Your reference:  
MCUI 2024\_5682/1

Further Submission from [REDACTED] against Development  
Application for Material Change of Use for Extractive Industry (30,000 tonnes per year) over Lot 1 on  
RP893855 – Development Application No. MCUI 2024\_5682/1 (Development Application)

Figure 1: Indicative Cross Section

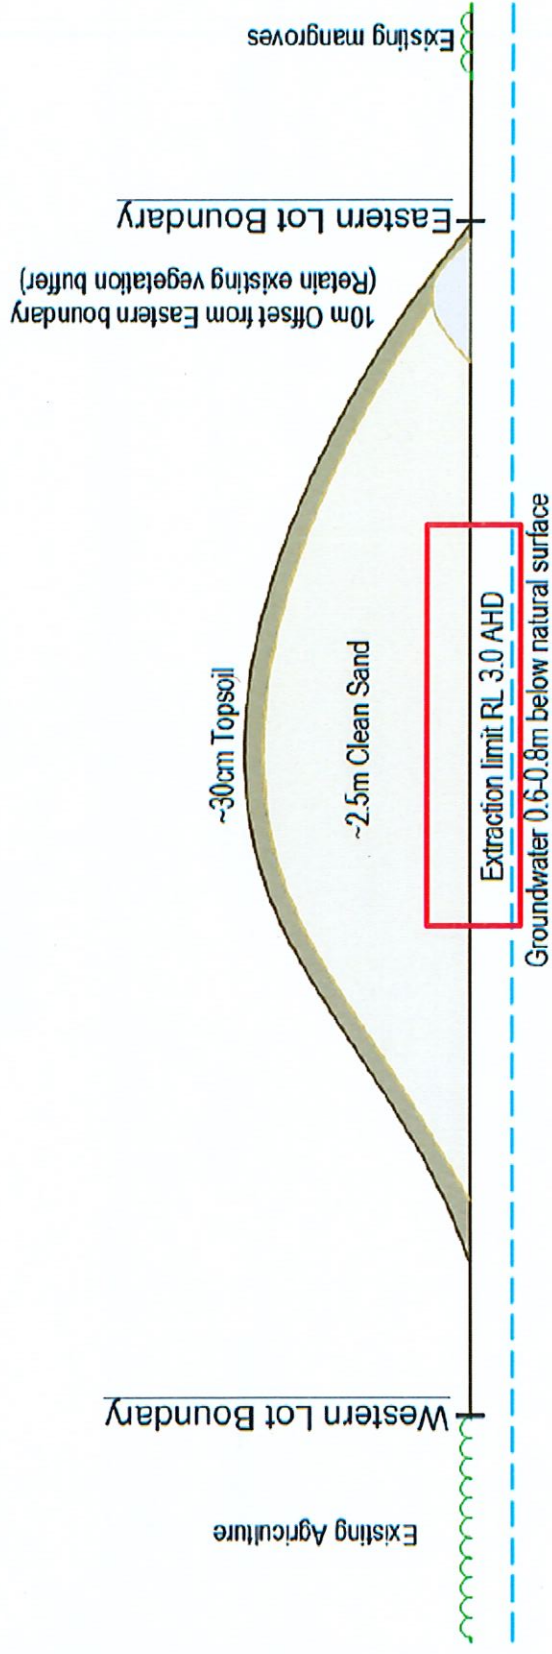
| No. | Response Letter                                                                                                                                                                                                                                                                                                                                                                                                                                                                                                                                                                                                                                                                                                                                                                                                                                                                                                                                                                                                                                                                                                                                                                                                                                                                                                                                                                                                                                                                                                                                                                                                                                                                                                                                                                                                                                                                                                                            | Impacts & Issues                                                                                                                                                                           |
|-----|--------------------------------------------------------------------------------------------------------------------------------------------------------------------------------------------------------------------------------------------------------------------------------------------------------------------------------------------------------------------------------------------------------------------------------------------------------------------------------------------------------------------------------------------------------------------------------------------------------------------------------------------------------------------------------------------------------------------------------------------------------------------------------------------------------------------------------------------------------------------------------------------------------------------------------------------------------------------------------------------------------------------------------------------------------------------------------------------------------------------------------------------------------------------------------------------------------------------------------------------------------------------------------------------------------------------------------------------------------------------------------------------------------------------------------------------------------------------------------------------------------------------------------------------------------------------------------------------------------------------------------------------------------------------------------------------------------------------------------------------------------------------------------------------------------------------------------------------------------------------------------------------------------------------------------------------|--------------------------------------------------------------------------------------------------------------------------------------------------------------------------------------------|
| 1   | <p><b>Inconsistent and Uncertain Extraction Levels and Base of Cut</b></p> <p>The Applicant provides an explanation for the extraction levels and a Figure 1 – Concept Design of Proposed Sand Extraction (<b>Sand Extraction Figure</b>). This shows a 30cm topsoil extraction, the retention of a 10m buffer on the eastern lot boundary and an extraction limit for RL3.0AHD. It is said that the extraction is not intended to create a depression on the site.</p> <p><b>However</b>, this is inconsistent with the Engineering Report and the earthworks drawings enclosed in Attachment 3 – General Drawings. In particular, these drawings (Drawing No. 102-008-SK17 and 102-00-SK18) (<b>Earthworks Drawings</b>) show a 1m offset along the eastern and western lot boundaries and the associated sections show a large depression for the cut (extraction) that has a base of RL1.05m.</p> <p>If the intent was for extraction only to the natural ground level aligning with the adjoining boundaries, then this should be clear on the Earthworks Drawings. The Earthworks Drawings in fact show a large depression being created, particularly in comparison to the adjoining eastern and western lot boundaries and the existing LiDAR surface levels. The Sand Extraction Figure also will result in a depression, having regard to the extraction limit and the adjoining boundaries. The two inconsistent drawings are shown in <b>Appendix A</b>.</p> <p>Furthermore, the borehole testing results in the DETSI Response indicate there are clay, mud and water levels between 2.5m to 4m in depth. It is unclear if there are groundwater impacts if there is an extraction limit of RL3.0m AHD in the Sand Extraction Figure or RL1.05m in the Earthworks Drawings, as both extraction limits/ base cut figures appear to potentially interact with the clay, mud and groundwater levels in the borehole testing.</p> | <p>This inconsistency is significant. This issue relates specifically to surface water, ground water, aquatic ecology and agricultural impacts that are yet to be properly considered.</p> |

SECTION B  
SCALE 1:1000 (H)  
SCALE 1:100 (V)

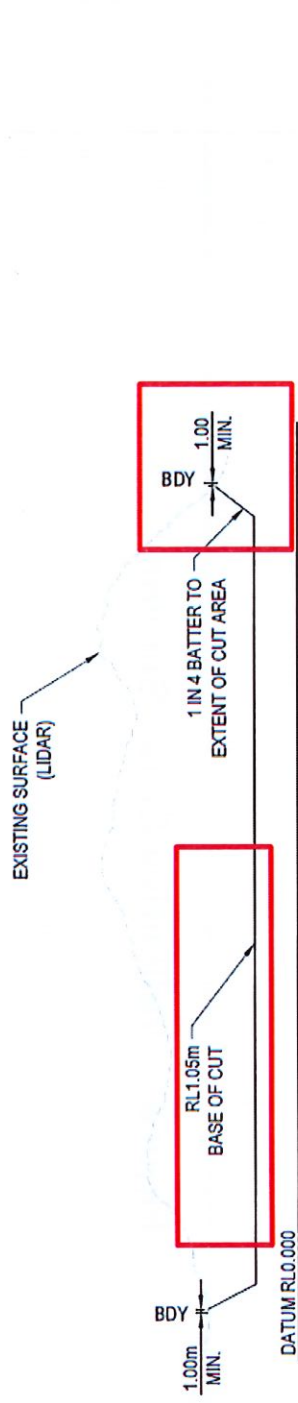
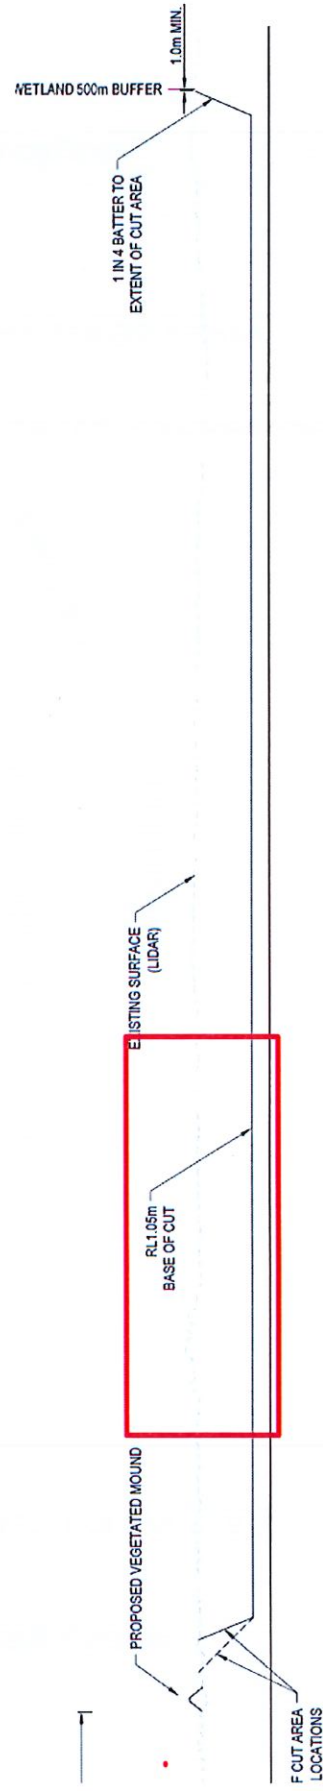
| No. | Response Letter                                                                                                                                                                                                                                                                                                                                                                                                                                                                                                                                                                                                                                                                                                                                                                                                                                                                                                                                                                                                                                                                                                                                                                                                                                                                            | Impacts & Issues                                                                                                                                                                                                                                                                                                                                                                               |
|-----|--------------------------------------------------------------------------------------------------------------------------------------------------------------------------------------------------------------------------------------------------------------------------------------------------------------------------------------------------------------------------------------------------------------------------------------------------------------------------------------------------------------------------------------------------------------------------------------------------------------------------------------------------------------------------------------------------------------------------------------------------------------------------------------------------------------------------------------------------------------------------------------------------------------------------------------------------------------------------------------------------------------------------------------------------------------------------------------------------------------------------------------------------------------------------------------------------------------------------------------------------------------------------------------------|------------------------------------------------------------------------------------------------------------------------------------------------------------------------------------------------------------------------------------------------------------------------------------------------------------------------------------------------------------------------------------------------|
| 2   | <p><b>New Unexplained Vegetated Mound</b></p> <p>The Earthworks Drawings show a large 'proposed vegetated mound' which is unexplained in the Response Letter. The purpose, height and dimensions remain unclear. Based on the sections, the height appears higher than the existing LiDAR surface level of the sand mounds on the site.</p>                                                                                                                                                                                                                                                                                                                                                                                                                                                                                                                                                                                                                                                                                                                                                                                                                                                                                                                                                | <p>This new change potentially results in increased impacts relating to surface water. However, while it could be an improvement, its purpose remains unclear.</p>                                                                                                                                                                                                                             |
